**RECLAMATION DISTRICT NO. 1608  
LINCOLN VILLAGE WEST  
BOARD OF TRUSTEES MEETING  
WEDNESDAY, FEBRUARY 3, 2016  
8:00 A.M.  
ENGINEER'S REPORT**

- a. **3502 Fourteen Mile Dr.  
Gregory R. & Julie A. Ebenhack  
(209) 969-7391 ofc, (209) 952-9791 (home)  
Index No. 419 Lot 46  
Assessor's Parcel No. 098-393-19**

Review replacement of 1973 permitted walkway from the deck to the levee

***EXHIBIT A: Ebenhack's Application for Approval of Plans and/or Encroachment Permit.***

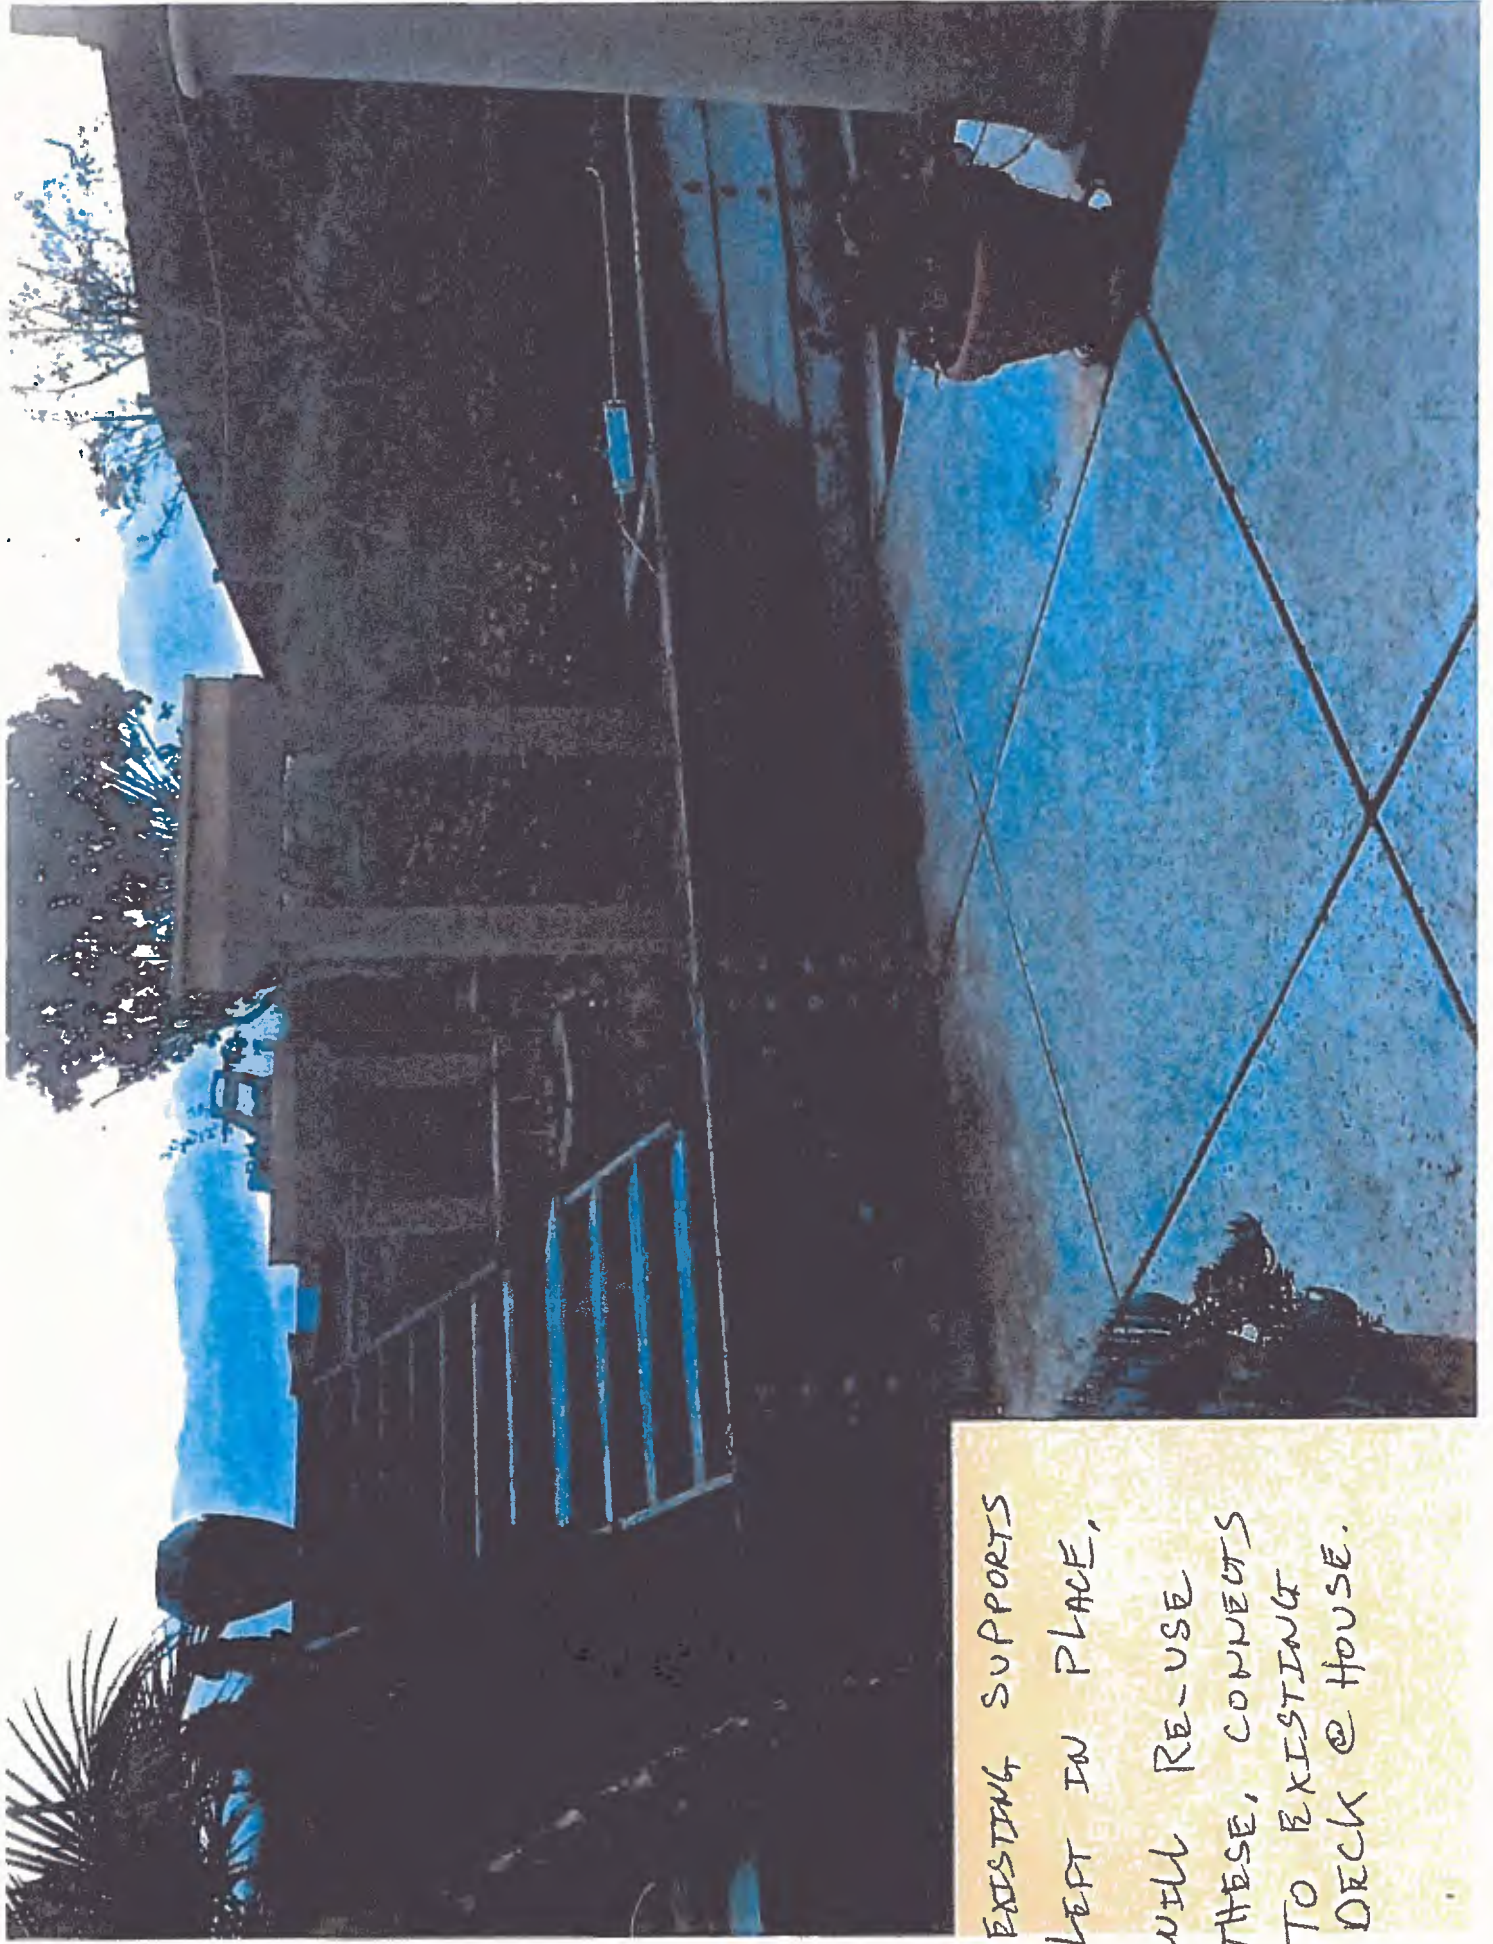
EXISTING SUPPORTS  
LEFT IN PLACE,  
WILL RE-USE  
THESE,

EXISTING SUPPORTS  
LEFT IN PLACE,  
WILL RE-USE  
THESE, CONNECTS  
TO EXISTING  
DECK @ HOUSE.

OLD WALKWAY  
THAT HAS BEEN  
REMOVED. TOP  
SECTION ONLY.  
ALONG W/HANDRAIL.  
(REMOVED)

PROPOSED NEW WALKWAY.  
 PRE MANUFACTURED FROM ALUMINUM  
 + GALV. STEEL. WILL LAY ON  
 EXISTING POSTS EXACTLY  
 WHERE OLD WALKWAY WAS, AS  
 THE DIMENSIONS WILL BE  
 EXACTLY THE SAME.

KSN Inc. recommends approval of this application with no special conditions.
